Tennessee Valley Authority, Watts Bar Nuclear Plant, Unit 2
Docket No. 50-391

**Subject: Revised Response to Request for Additional Information
Question 3 Regarding Final Safety Analysis Report Section 2.4
(TAC NO. ME3945)**

ENCLOSURE 2
REVISED FSAR FIGURE 2.4-72

EMBANKMENT
RESULTS OF ANALYSIS FOR
OPERATING BASIS EARTHQUAKE
Fort Loudoun Dam
Figure 2.8-72

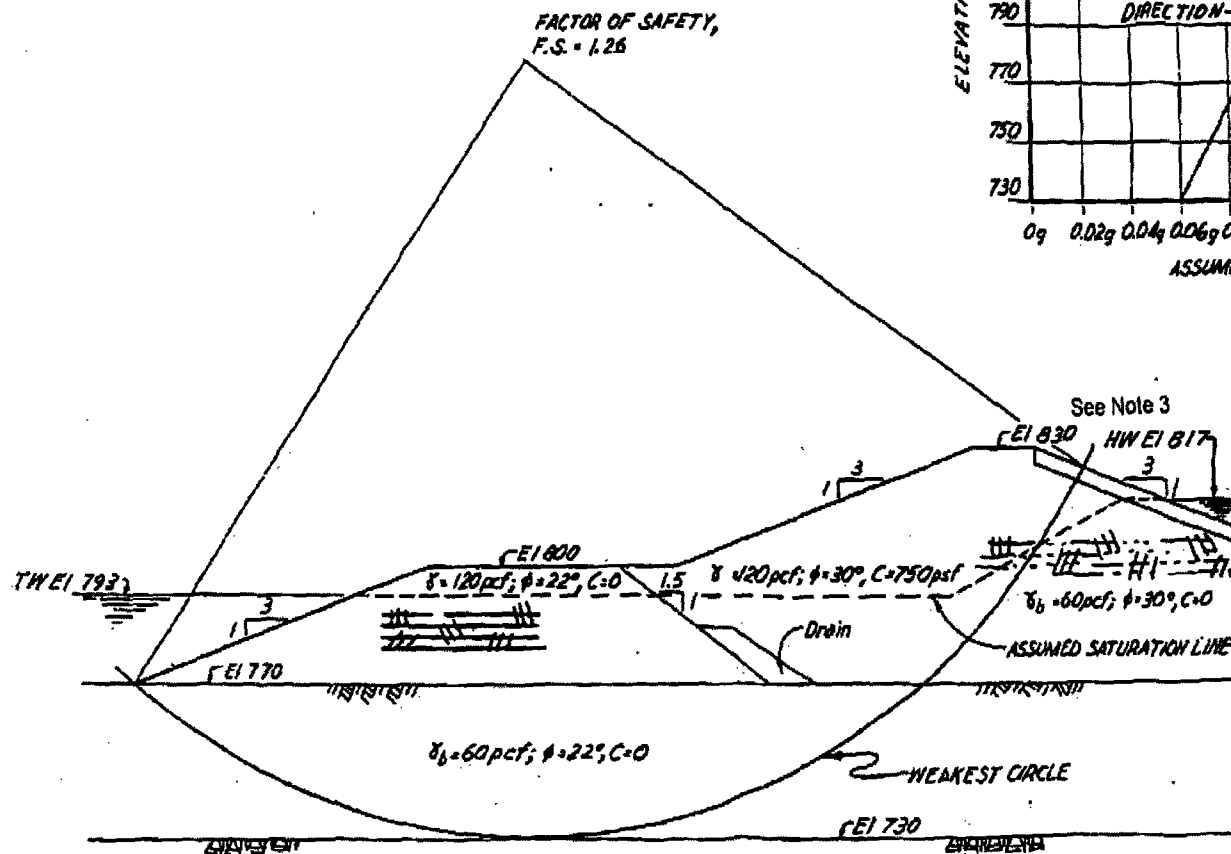
Regarding the RAI question 2 response submitted in the referenced letter, TVA agreed to revise FSAR Figure 2.4-72 to show the sand baskets. An FSAR Change Request has been submitted to include this revision in FSAR Amendment 104. A copy of the Figure submitted with the Change Request is provided in Enclosure 2. Note 3 was added to Figure 2.4-72 to describe the sand baskets.

1. Analysis was made using the standard slip circle method.
2. Shear strengths of materials same as used in original analysis.
3. Improvements have increased the effective height of the embankment to a minimum EI 836 (See Fort Loudoun Project Drawing 10W222-1). Field surveys indicate a minimum height of EI 838.9 was achieved.
